No. 89-31

Alpha One - Bravo One and Bravo Two Trim Sender Indexing Marks Misaligned

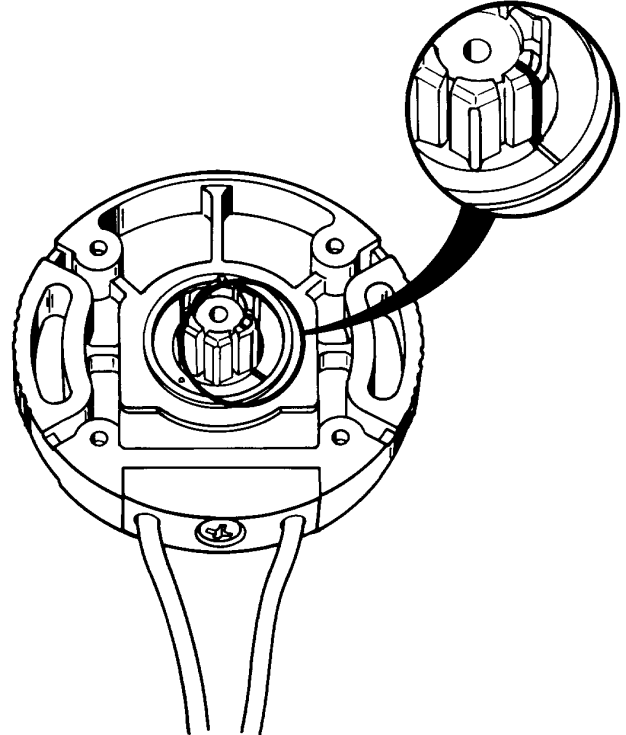
It has been brought to our attention that the indexing marks on the Alpha One and Bravo One and Bravo Two trim position sender may not be aligned properly. Please remove and align indexing marks as shown in the following diagram. When indexing marks are misaligned the trim gauge needle will jump to the top end of the gauge scale when trimming. Units affected are from serial number 0C833540 thru 0C888889.

IMPORTANT: Sender adjustment must be done with stern drive at full down "IN" position. DO NOT adjust sender with stern drive at maximum trim position because sender may be damaged or give incorrect gauge readings.
